REMARKS

This is intended as a full and complete response to the Office Action dated July 20, 2005, having a shortened statutory period for response set to expire on October 20, 2005. Please reconsider the claims pending in the application for reasons discussed below.

IN THE DRAWINGS:

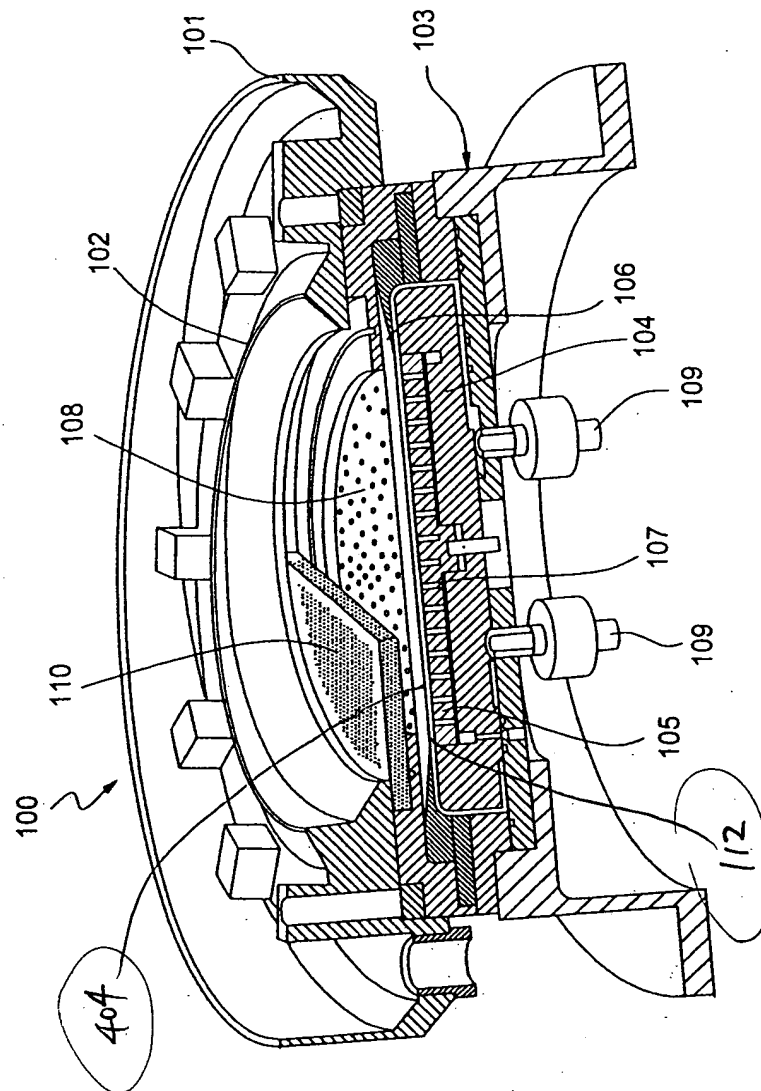
The drawings stand objected by the Examiner because element 112 is missing in the Figures. Applicants have amended Figures 1 and 5 to correct informalities and indicate the location of the membrane 112 as supported by the Specification at least in paragraphs 22-23 without introducing new matter. Withdrawal of this objection is respectfully requested.

In Figure 1, previously omitted reference number 404 and 112 have been added.

FIG. 4

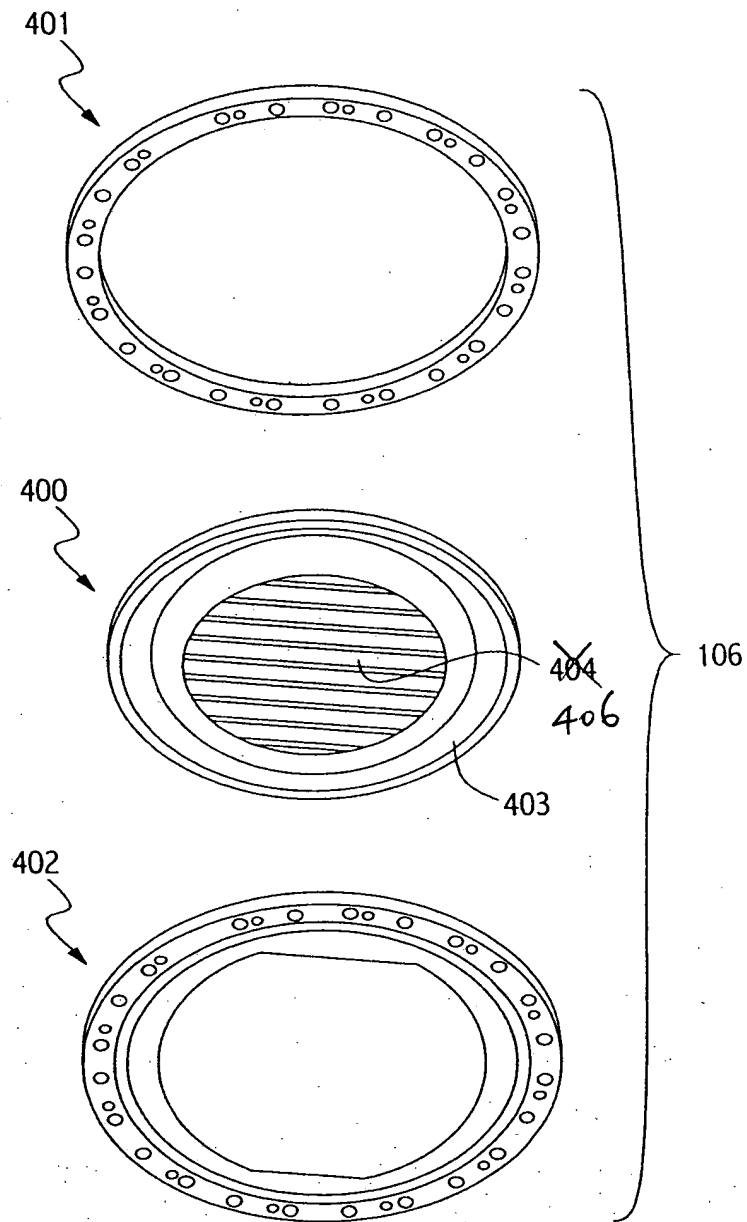
In Figure 4, reference number 404 has been renumbered to 406.

FIG. 5

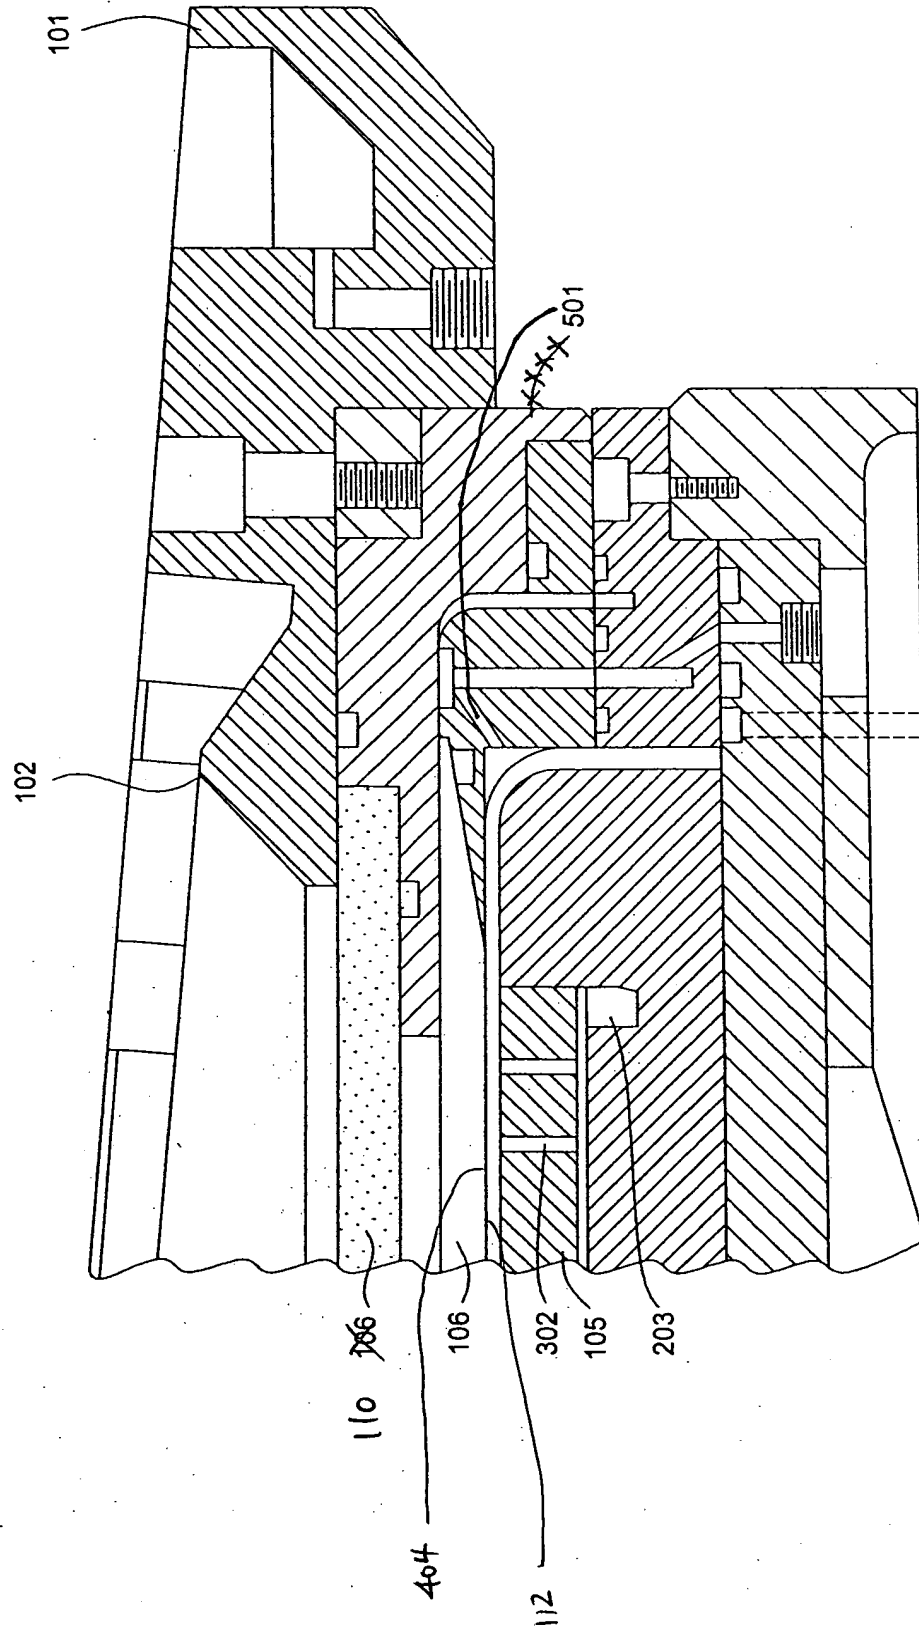
In Figure 5, previously omitted reference number 404 and 112 have been added, the lead line for reference number 501 has been corrected, and one of the duplicated reference number 106 has been changed to 110.
